HISTORIC AND DESIGN REVIEW COMMISSION

June 20, 2018

HDRC CASE NO: 2018-258
ADDRESS: 201 LEIGH ST
LEGAL DESCRIPTION: NCB 720 BLK 2 LOT S 73 FT OF 1
ZONING: RM-4, H
CITY COUNCIL DIST.: 1
DISTRICT: Lavaca Historic District
APPLICANT: Richard Tavizon
OWNER: Richard Tavizon
TYPE OF WORK: Install stucco skirting around foundation
APPLICATION RECEIVED: May 15, 2018
60-DAY REVIEW: July 14, 2018
REQUEST:

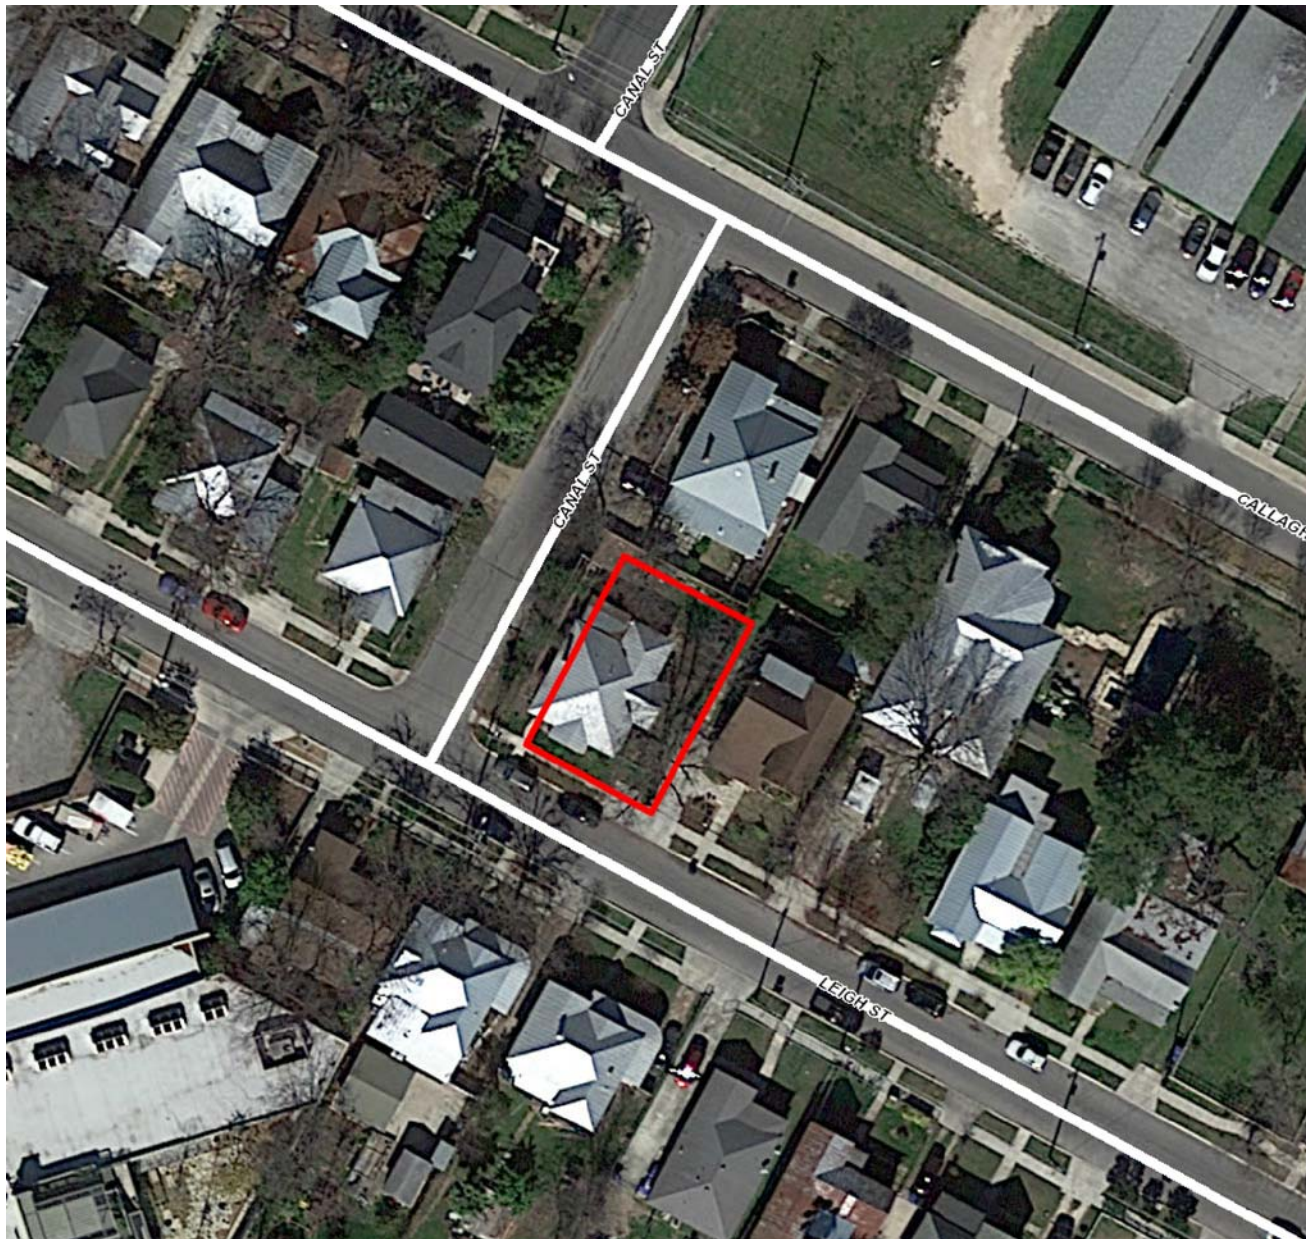
- a. The structure at 201 Leigh was constructed circa 1907 in a Craftsman architectural style. The structure features a symmetrical front facade with three non-original fixed windows with latticed transoms on each side of the center door. The structure features a primary standing seam metal hipped roof, wood siding, and flared skirting with wood siding. The flared skirting is a character-defining feature of this Craftsman structure.
- b. **STUCCO SKIRTING** – The applicant is requesting to install stucco skirting up to 18 inches from grade over the flared wood skirting. Staff finds that the structure previously featured wood siding on the entirety of the skirting and that in-kind replacement is feasible. If the applicant is concerned with water infiltration, staff finds the installation of smooth-finish hardie board immediately at grade would be appropriate.

Staff does not recommend approval of the installation of stucco skirting based on finding a and b. Staff recommends that the skirting should be replaced in-kind (wood siding with flare to match the existing) with the option of smooth-finish Hardie board immediately at grade.
